# UNITED STATES PATENT AND TRADEMARK OFFICE

APPLICATION NO.	FILING DATE	FIRST NAMED INVENTOR	ATTORNEY DOCKET NO.	CONFIRMATION NO.
10/803,717	03/18/2004	Larry Hurst	9H01.1-011	6987

**Office Action Summary**

### **DETAILED ACTION**

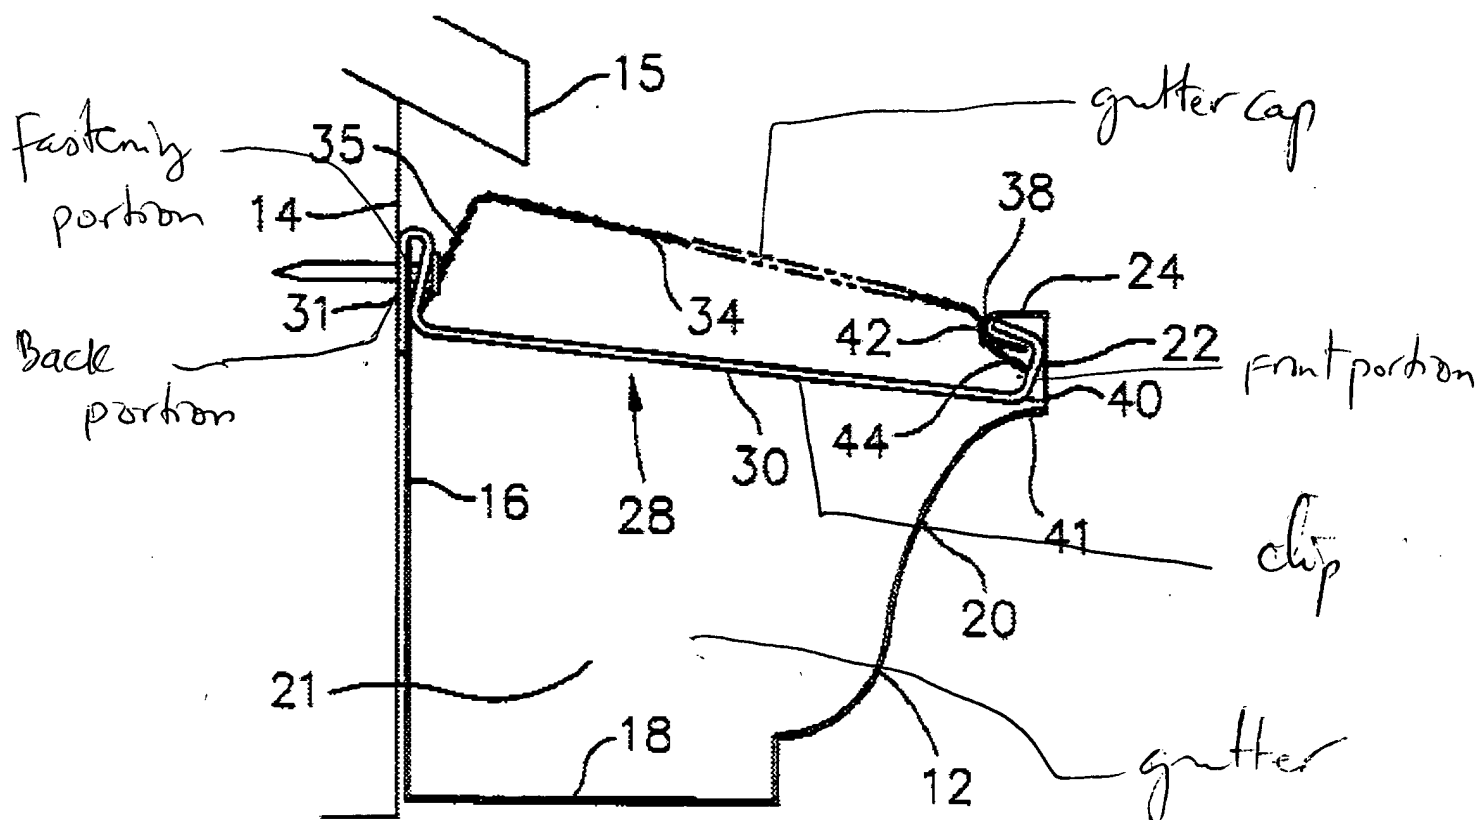
Leroney et al. teaches a clip for attaching a gutter cap (34) to a gutter (12, 16, 18, 20, 22, 24), the clip comprising (see marked-up copy): a front portion having a shape configured to interlock with a front hem edge of the gutter; a back portion having a shape configured to interlock with an edge of the gutter cap; and a support bracket having a shape configured to rest against the gutter to maintain the clip in an installment position.

Regarding claim 2, the clip of claim 1, further comprising: a fastening portion configured to receive a fastening device that is fastened to a back portion of the gutter, wherein the fastening portion enables the clip to be used with gutters of different sizes.

Regarding claim 3, wherein the variable fastening portion has an opening formed therein and wherein the fastening device is a screw that is screwed into the back portion of the gutter, and wherein an amount by which the screw is screwed into the back portion of the gutter depends at least in part on the size of the gutter.

Regarding claim 4, wherein said back portion of the clip has the shape configured to interlock with a hem edge of a gutter cap.

Regarding claim 5, wherein the supports bracket has the shape configured to rest against an inside front surface of the gutter.
